Commerical Unit 01
Existing & Proposed
External Seating Area Elevations

July 20	19	PP.U1.03	B rev.
scale @ A1		job no.	
	1:50	1658

PROPOSED - ELEVATION - CLOSED WINDOWS

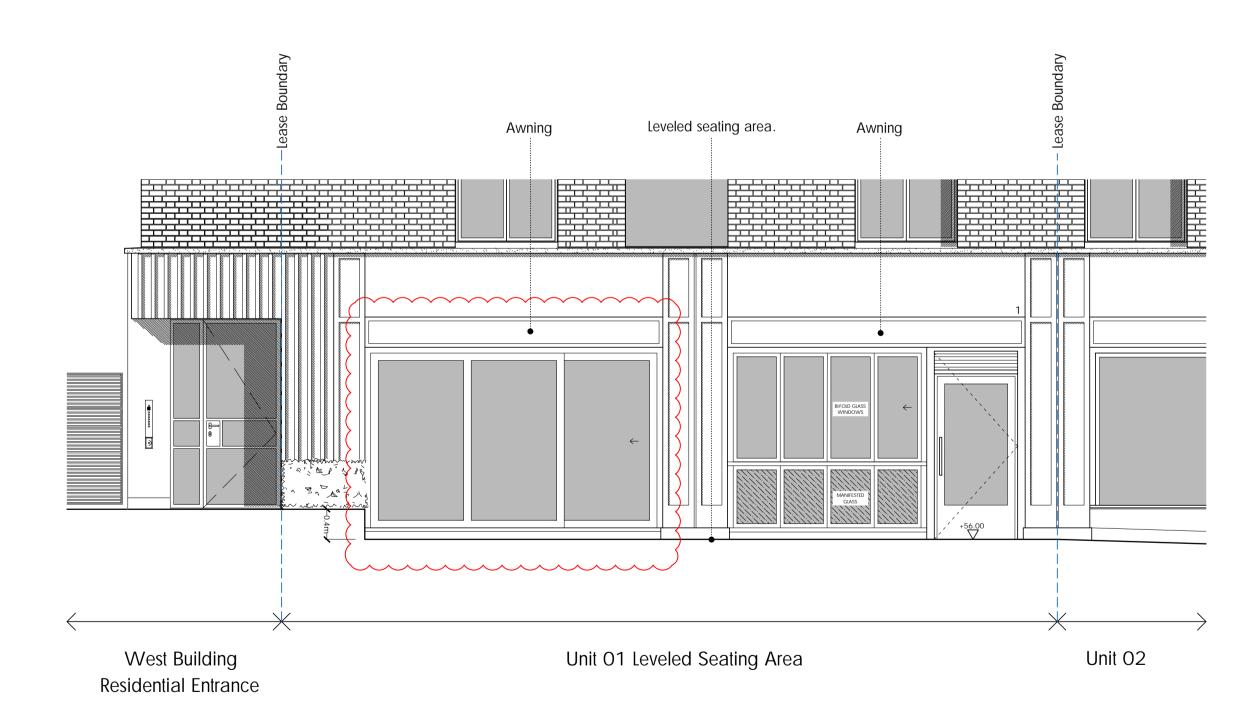
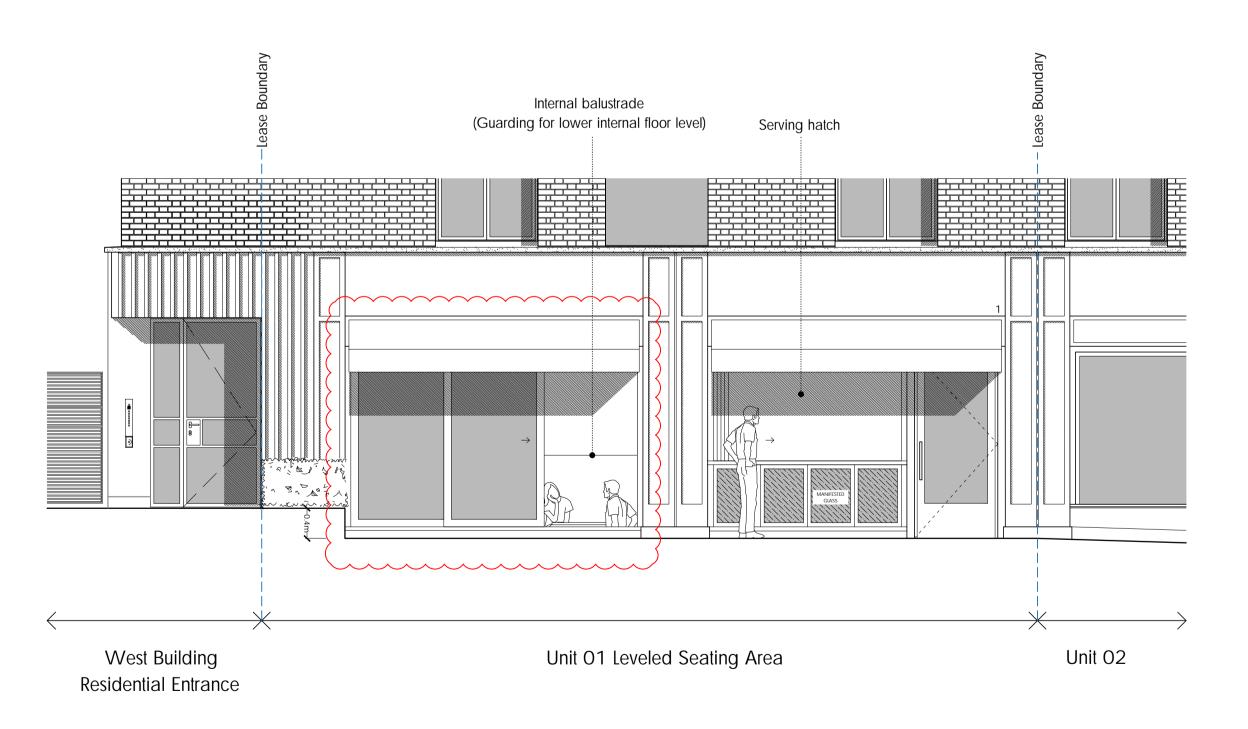
RHS revised to sliding door.

Vent over Unit 1 door added.
